UNITED STATES PATENT AND TRADEMARK OFFICE

APPLICATION NO.	FILING DATE	FIRST NAMED INVENTOR	ATTORNEY DOCKET NO.	CONFIRMATION NO.
10/733,539	12/11/2003	Timothy A. Tamcsin	20030317.ORI	2641

Office Action Summary

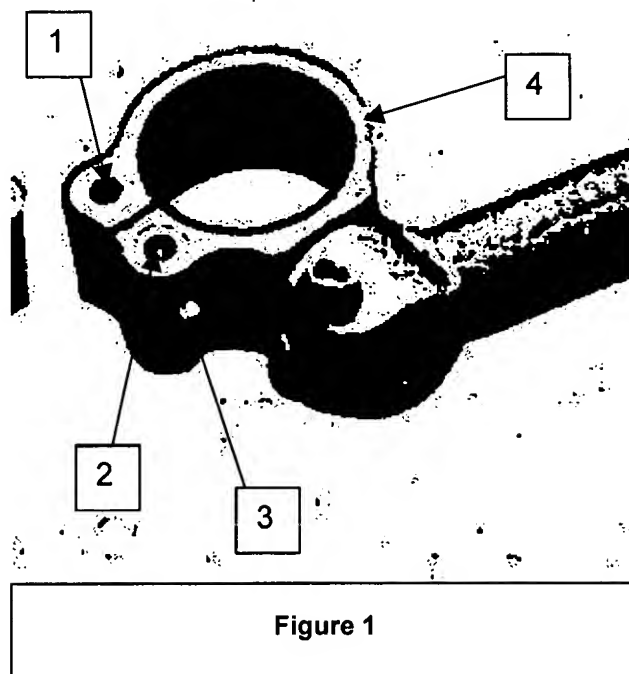
Twobros (see Figure 1 in this action) teaches a split ring clamping arrangement in which a locking portion integral with the split ring has a first post aperture (2) and a second post aperture (1), one on either side of a gap in the split ring, and a bolt aperture (shown by the positioning of bolt 3) through the locking portions, a first post having a smooth wall aperture there through and a second post having an aperture with a threaded wall there through (this is clearly true from the illustration), and a bolt (3) for extending through the locking portion apertures and the posts for engaging the threads of the second post to adjust the size of gap between the locking portions. This arrangement is taught as useful to distribute the clamping load over the entire split ring. Accordingly it would have been obvious to one of ordinary skill in the adjustable handle bar clamp art at the time of applicant's invention, to modify an arrangement as disclosed by Kobacker to include a clamping arrangement as taught by twobros for the purpose of evenly distributing the clamping load.
